ADDENDUM NO. SEVEN

October 8, 2024

Lamont Park Beautification Project

1650.7012.22

DESIGNED BY	LCD.09
DRAWN BY	
CHECKED BY	
DATE	10/2/2024

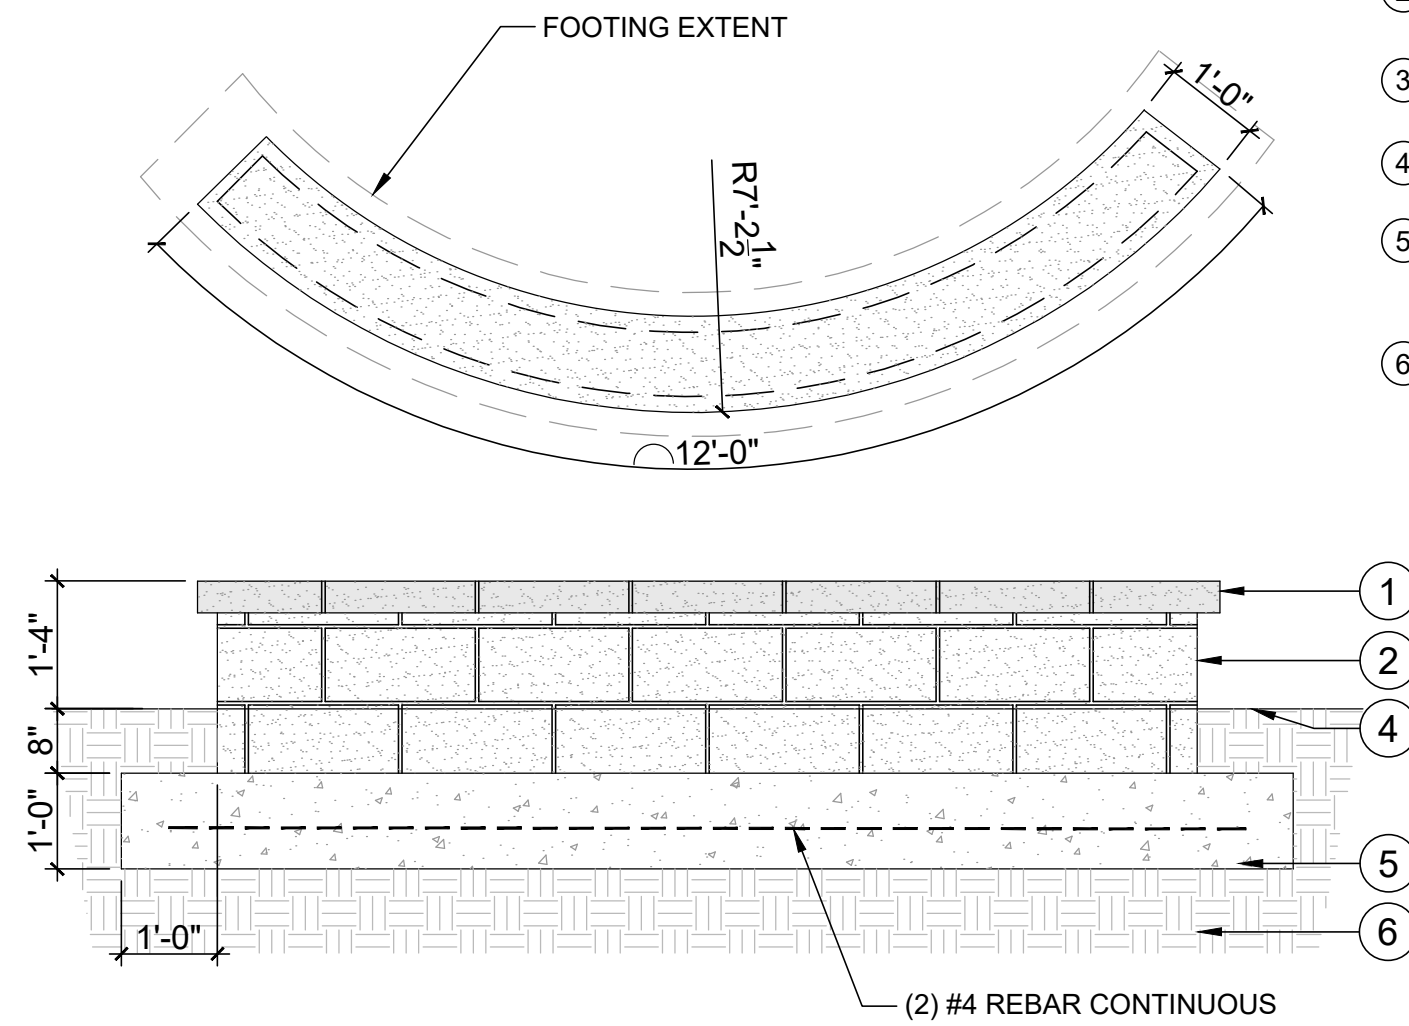
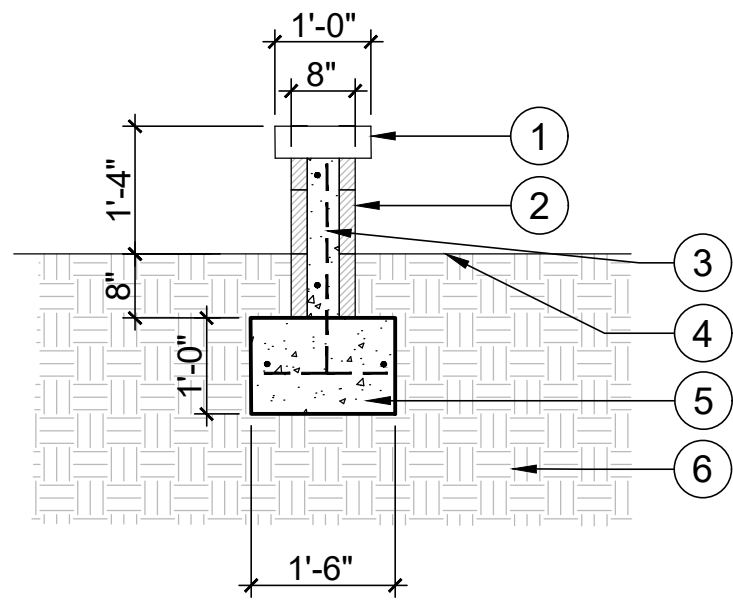
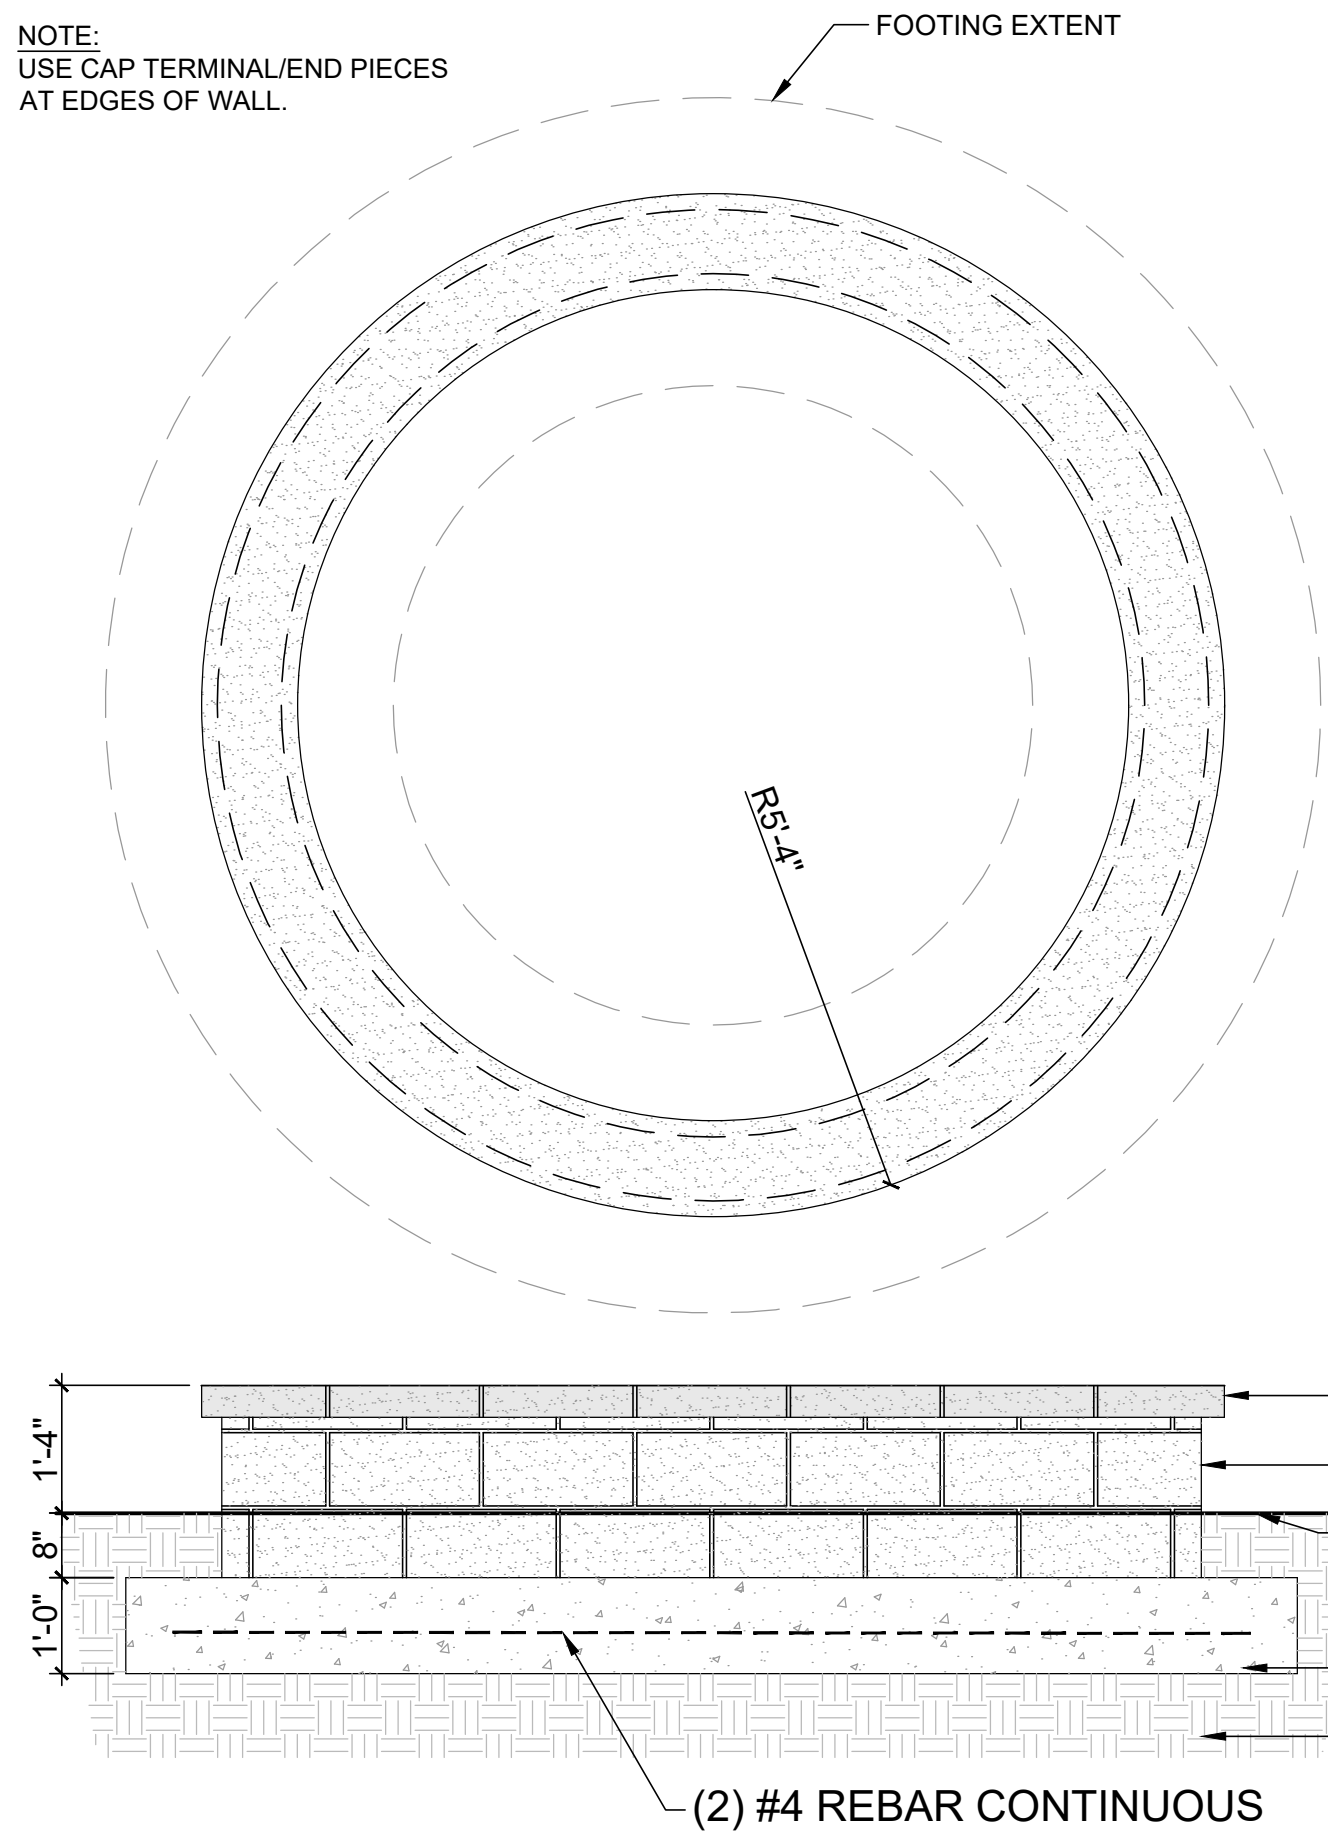
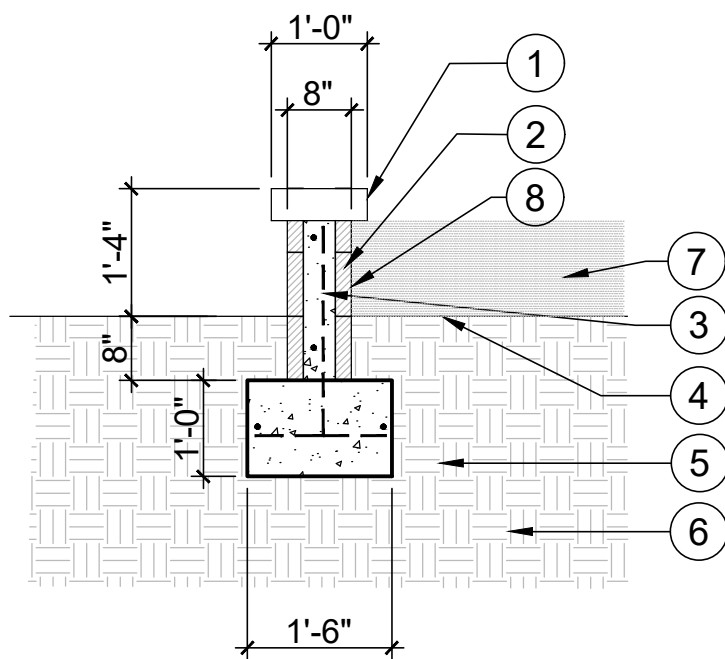
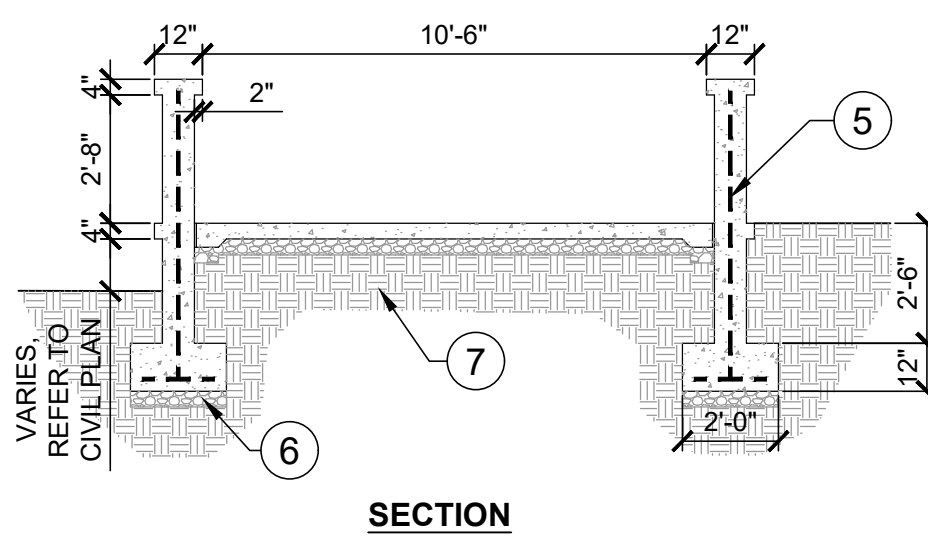
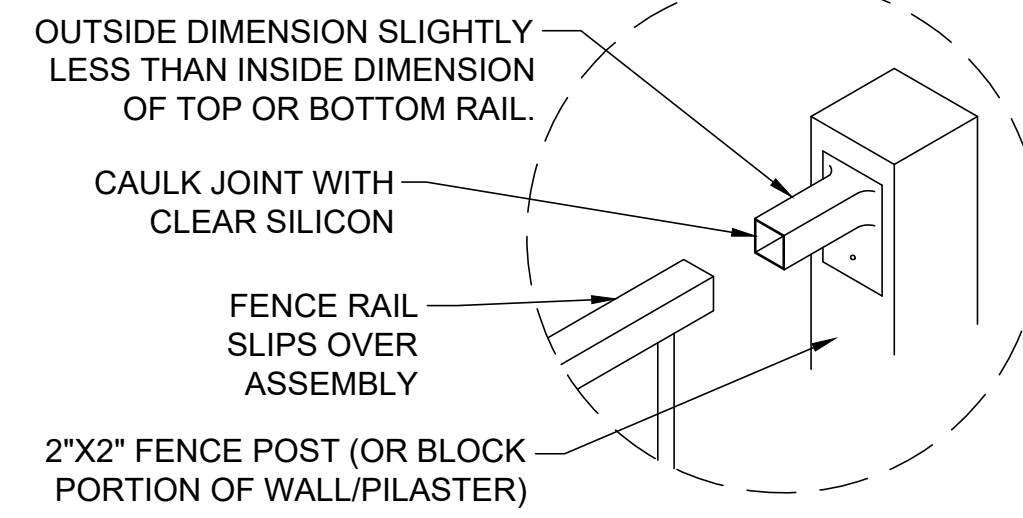
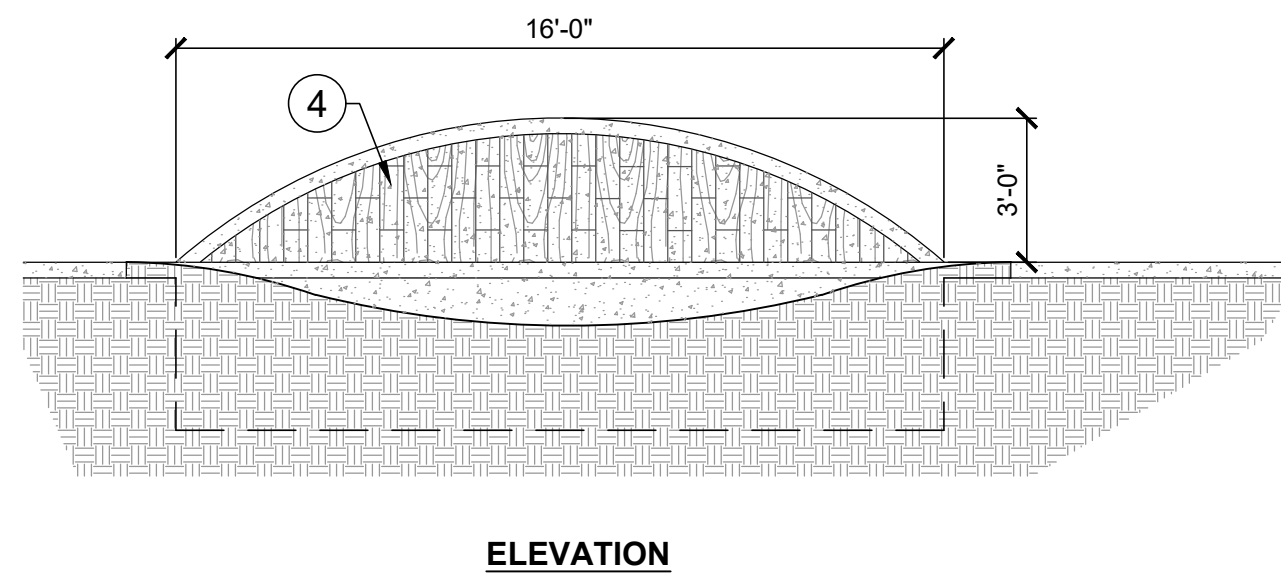
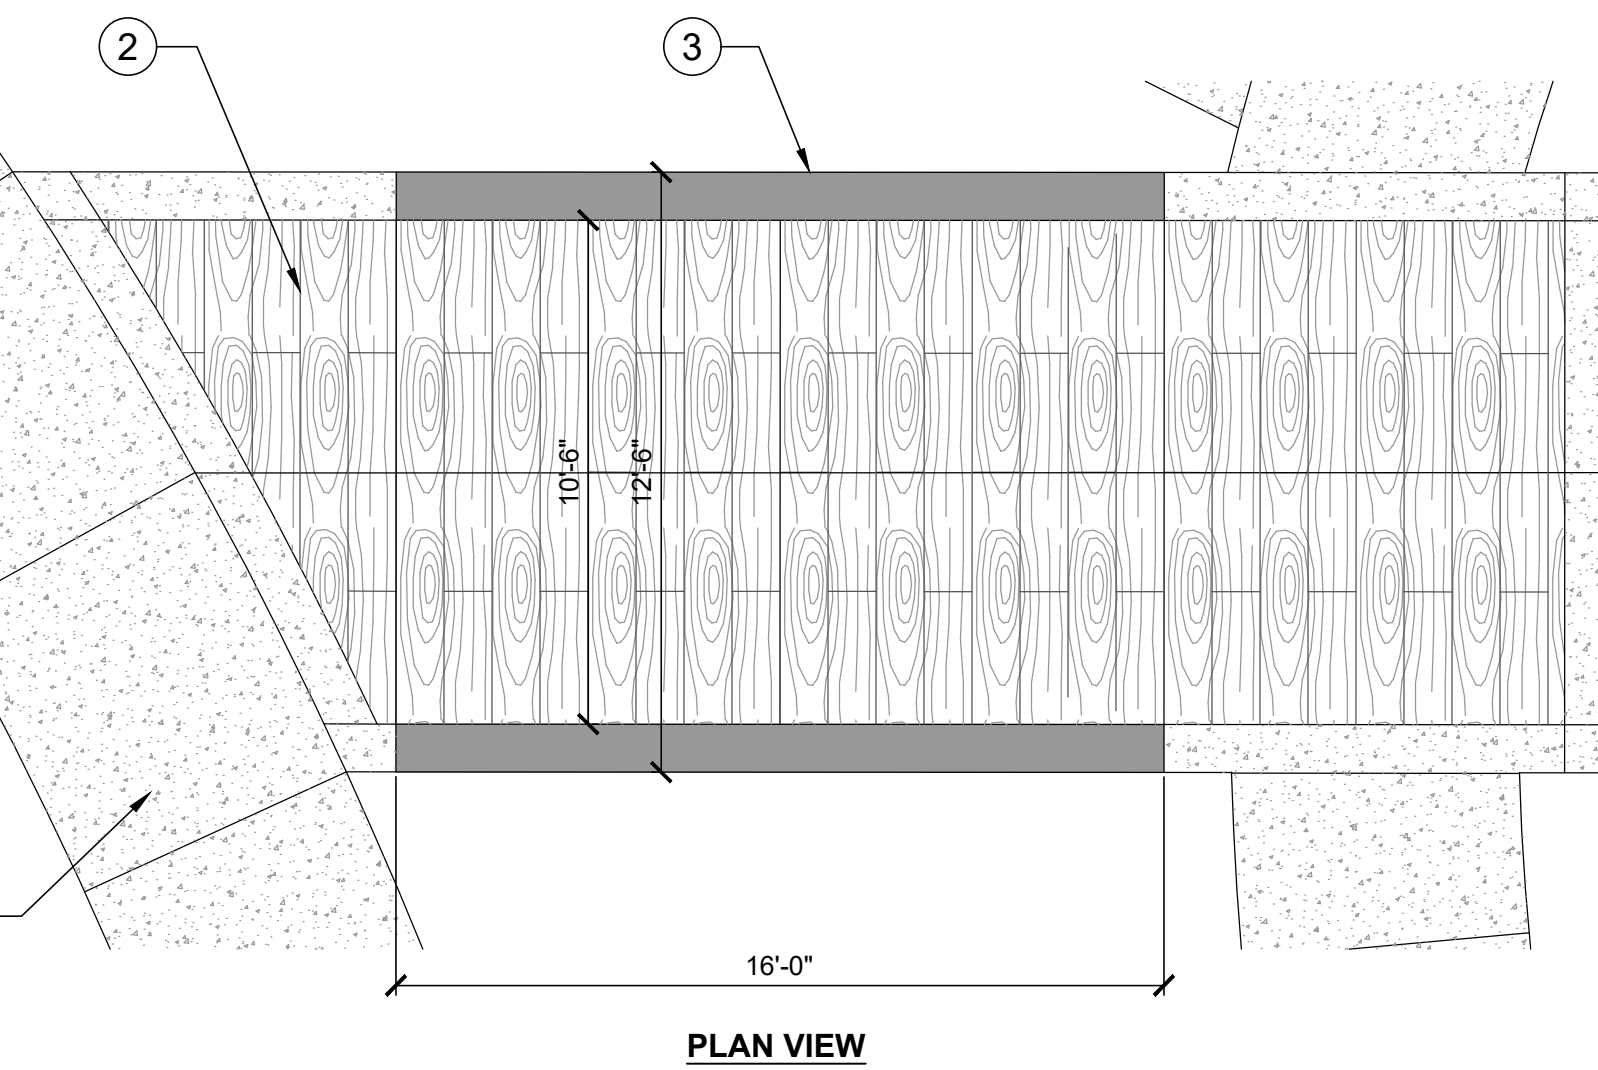
- Item No. 3:** Refer to Reflected Ceiling Plan sheet A300, ceiling joist shall be attached to beneath the trusses, not 2'-0" below.
- Item No. 4:** Refer to sheet LC.02 for call out C-04. Detail can be found on sheet LCD.09.

- Item No. 5:** Refer to sheet LC.02 for call out C-05. There are two locations adjacent to the Splash Pad. Refer to revised sheet LCD.09 for detail. See item no. 13 below.

- Item No. 6:** Refer to sheet LCD.09 for details on call out C-04 & C-05.
- Item No. 7:** Shotcrete is acceptable for use on Skate Park.
- Item No. 8:** Refer to attached sheet LCD.05 and replace existing sheet LCD.05 in its entirety. A thickened beam and dowels will be added at the top of the skatepark wall. Refer to details on attached LCD.05.

- Item No. 13:** Refer to attached sheet LCD.09 and replace existing sheet LCD.09 in its entirety.
